Work Session Memorandum

To: Salt Lake City Historic Landmark Commission
From: Kelsey Lindquist, Principal Planner
801 535 7930 or kelsey.lindquist@slcgov.com
Date: September 6, 2018
Re: PLNHLC2018-00557 and PLNHLC2018-00558 4th Avenue Pump House New Construction

4TH AVENUE PUMP HOUSE NEW CONSTRUCTION

REQUEST: 4th Avenue Pump House – The Historic Landmark Commission will hold a work session to provide preliminary review of a proposal and application by Salt Lake City Public Utilities for the new construction and special exceptions associated with the new pump house located at 300 N. Canyon Road. The pump house is necessary to continue to provide drinking water to the community and protect the well that is located on the site. The pump house will contain equipment necessary to operate the well and required chemicals to treat the water. The upgrade and pump house is required per federal and state regulation. This will be a work session review, no formal public hearing will be held and a decision will not be made at this meeting. The subject property lies within the Avenues Historic District (H Historic Preservation Overlay), is zoned OS (Open Space) and is within Council District 3

DRAWING NO. L-1

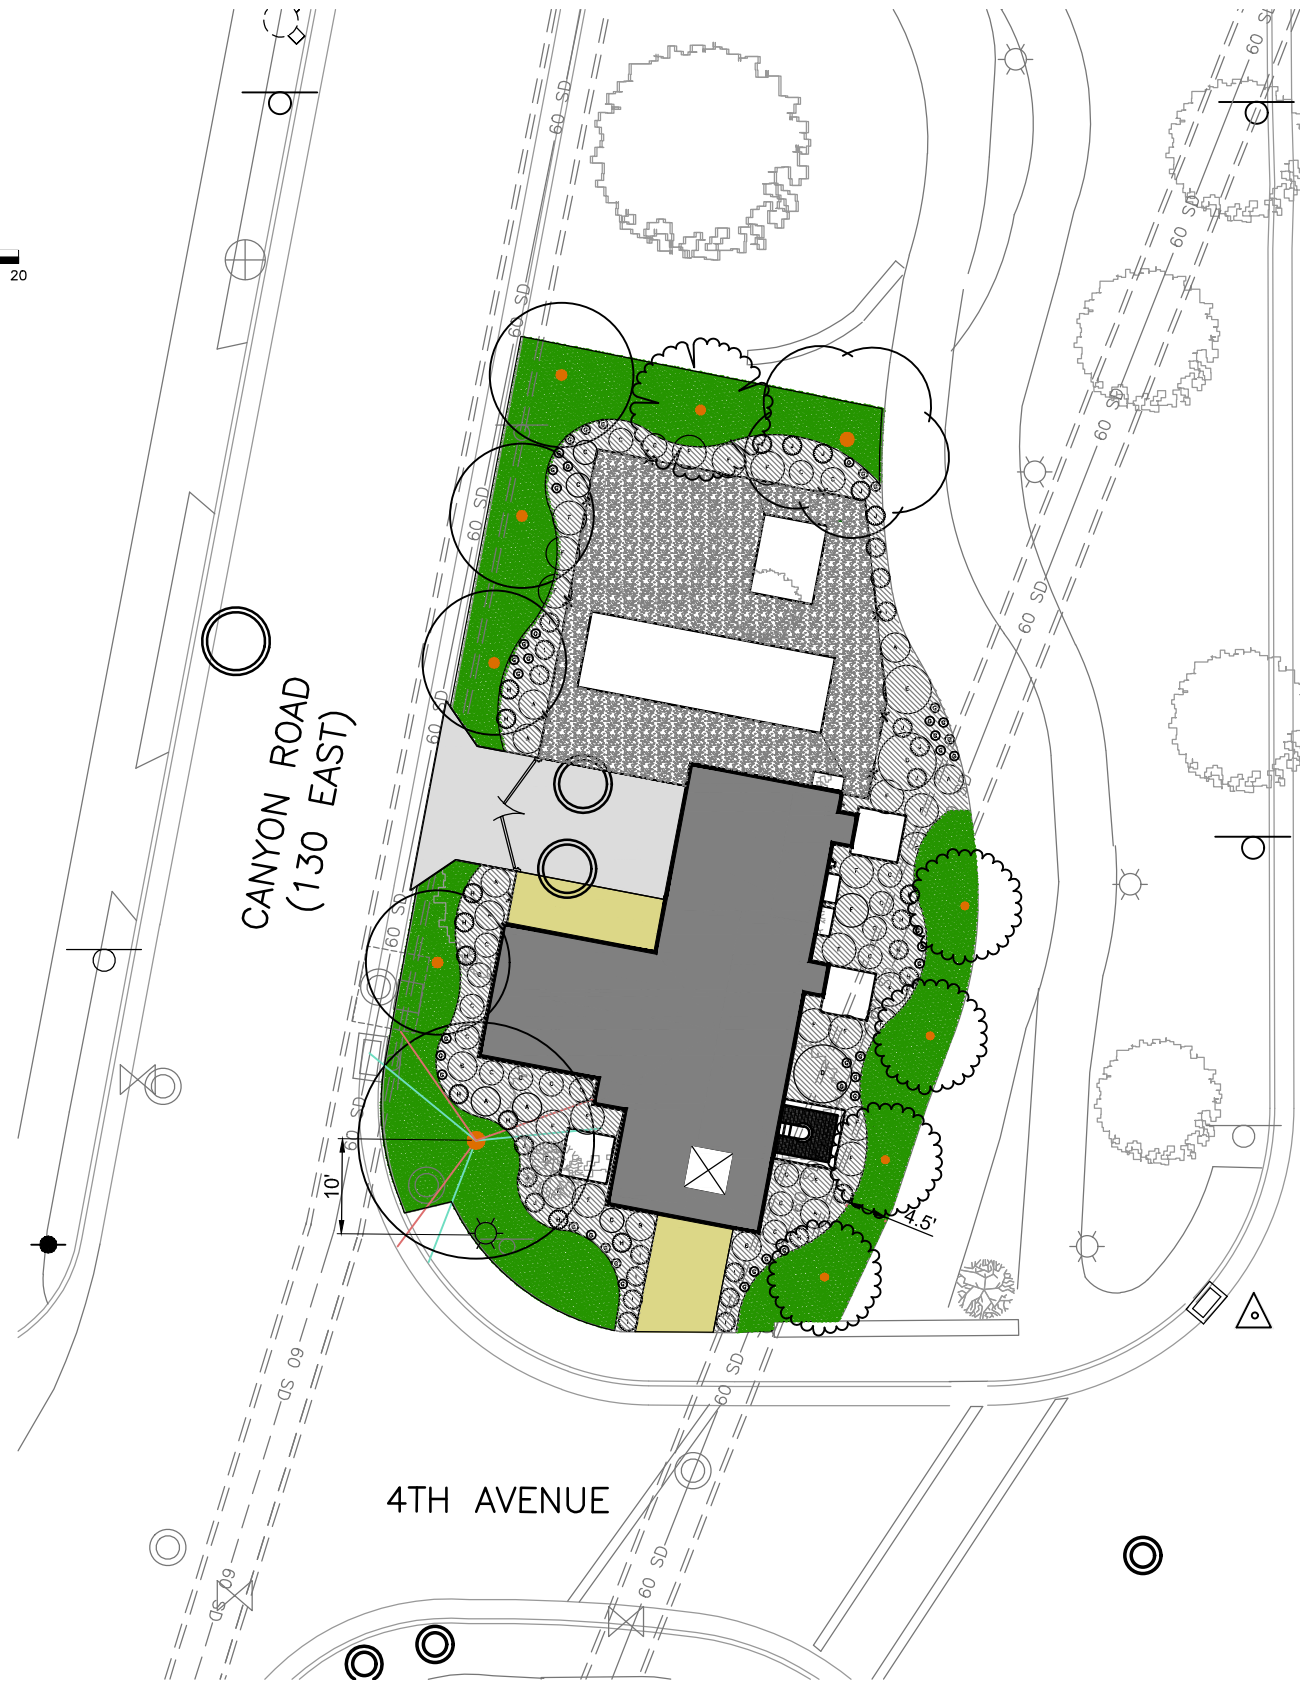
OAK TREES PLACED AT THE REQUEST OF
SLC PLANNING DEPARTMENT

NO.	DATE	REV. BY	DESCRIPTION
1	8/13/18	BMO	OAK TREES ADDED & PLANTING BEDS REVISED

DRAWING NO. A-01
SHEET 6 OF 10

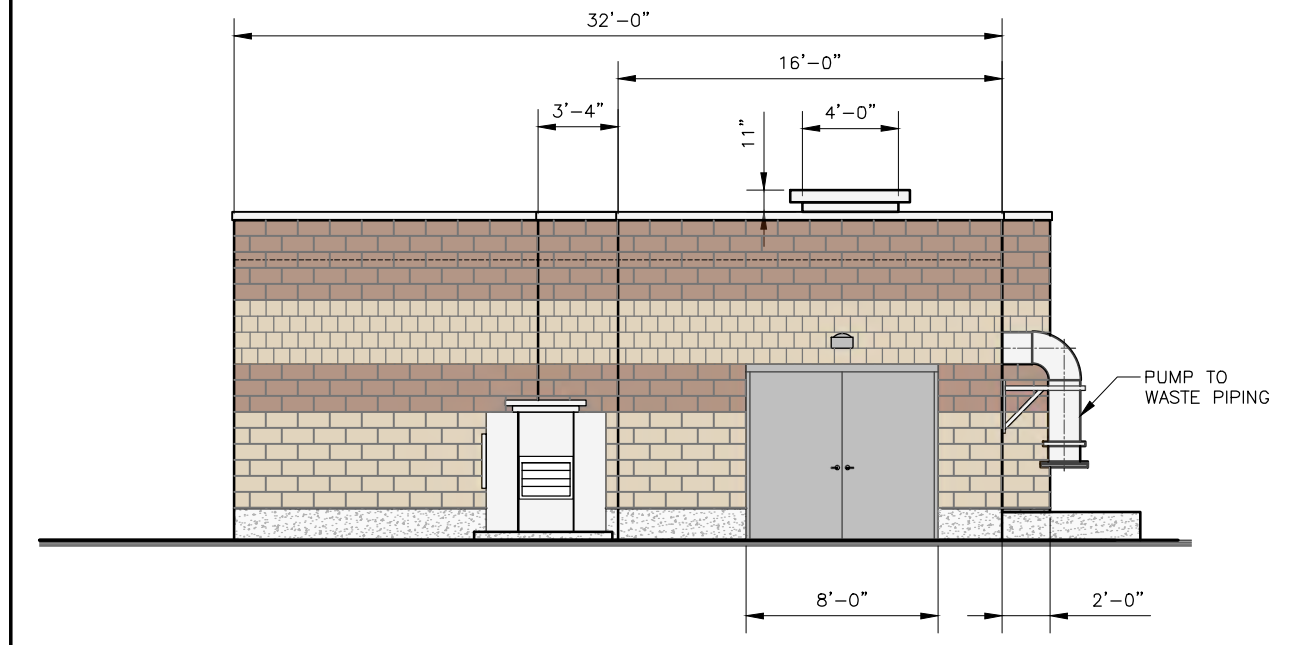
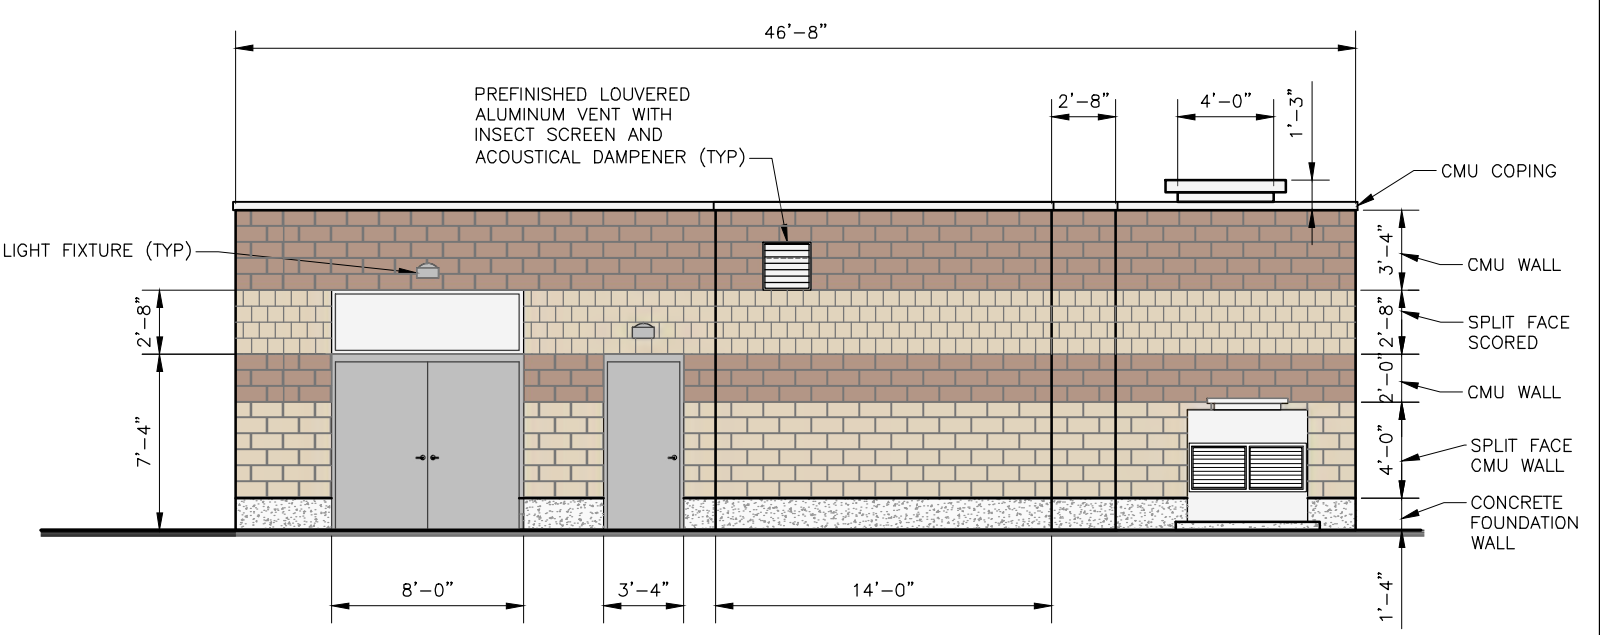
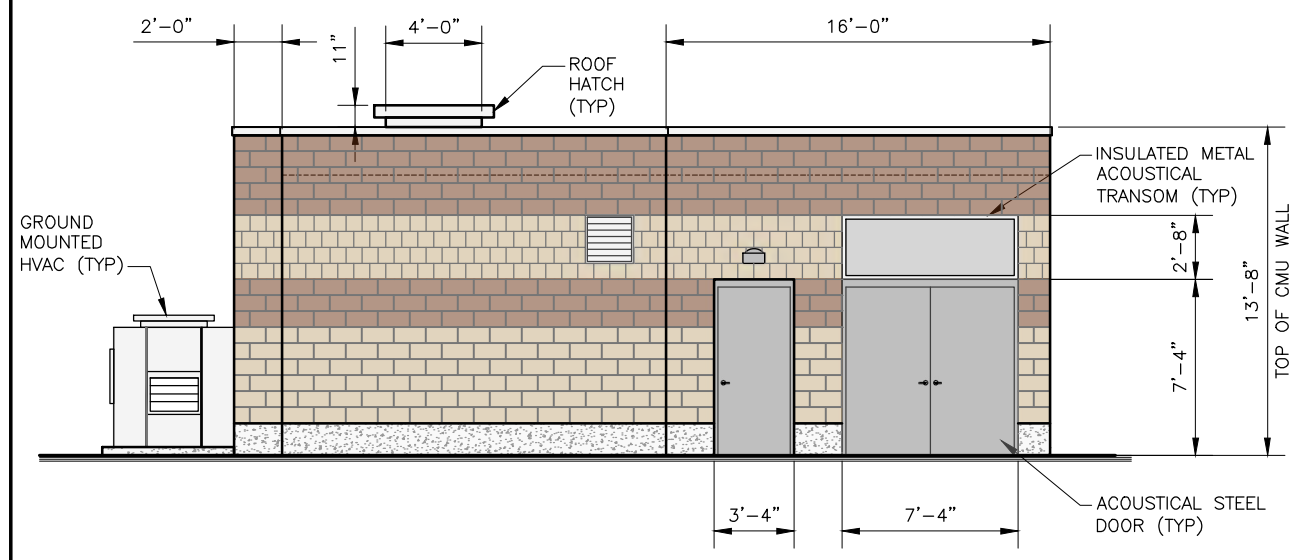
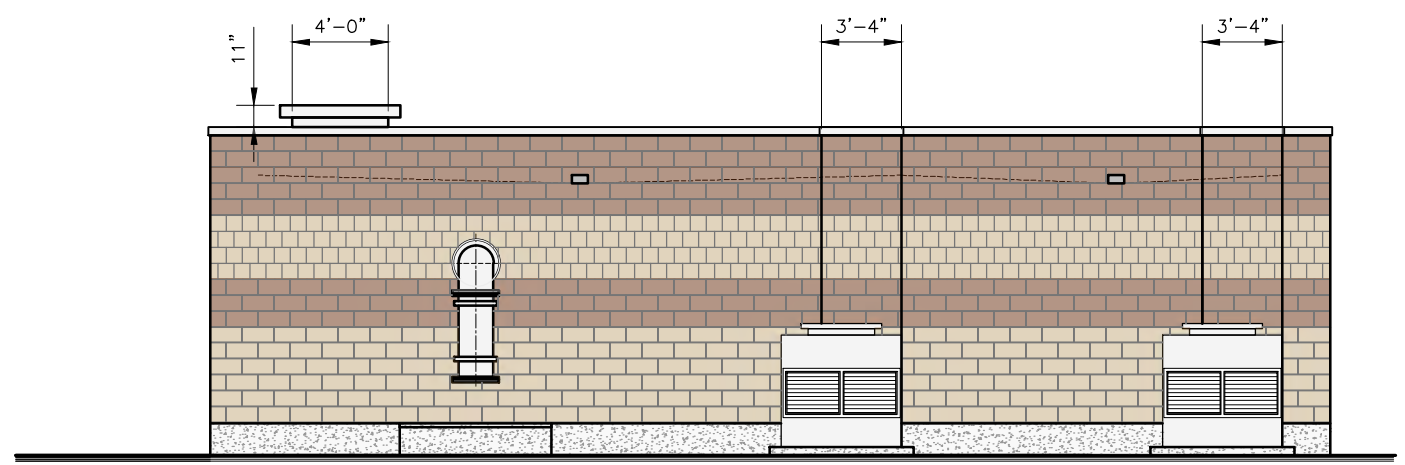
4. Does the design include enough design details to create a smooth transition from the open space to an established historic neighborhood?
Public Utilities has designed the structure with CMUs and added a split face CMU. The building consists of a concrete foundation, split face CMU, regular CMU, split face scored CMU and regular CMU. The engineers tried to integrate additional detailing with the variety of CMUs, the parapet, and the coping. Staff has encouraged the integration of a green screen, cornice and potential belt coursing to provide undulation and material variation. Conflict with Standard 1c, 1d, 1e, 3, 4a(1-3), 5a (1-4) and 6.
